MIXED USE DEVELOPMENT - (SSD-89869959) – 10 DANGAR STREET WICKHAM

Pre-Development Application No:	PR2026/01016 (SSD-89869959)
Land:	Lot 1 DP 1197377
Property Address:	10 Dangar Street Wickham
Proposed Development:	Construction of a 43-storey (plus plant) mixed use tower, comprising residential apartments, co-living apartments, ground floor retail, hotel component and concurrent rezoning proposal via a SSD application.

Figure 1 – Extract of existing stormwater details Source Onemap

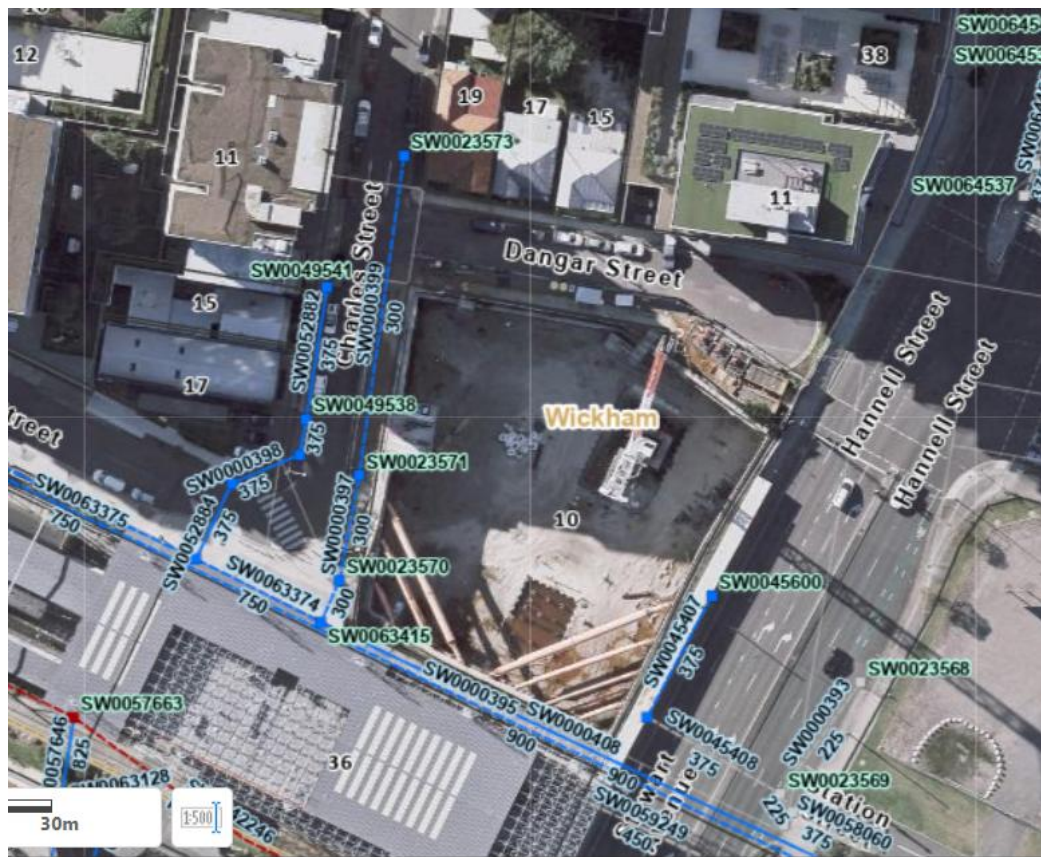
There is existing underground road drainage along Station St and the through link (see **Figure 1** below). CN notes that the previous approved developments on this site were designed to retain the existing drainage pipe and structures.
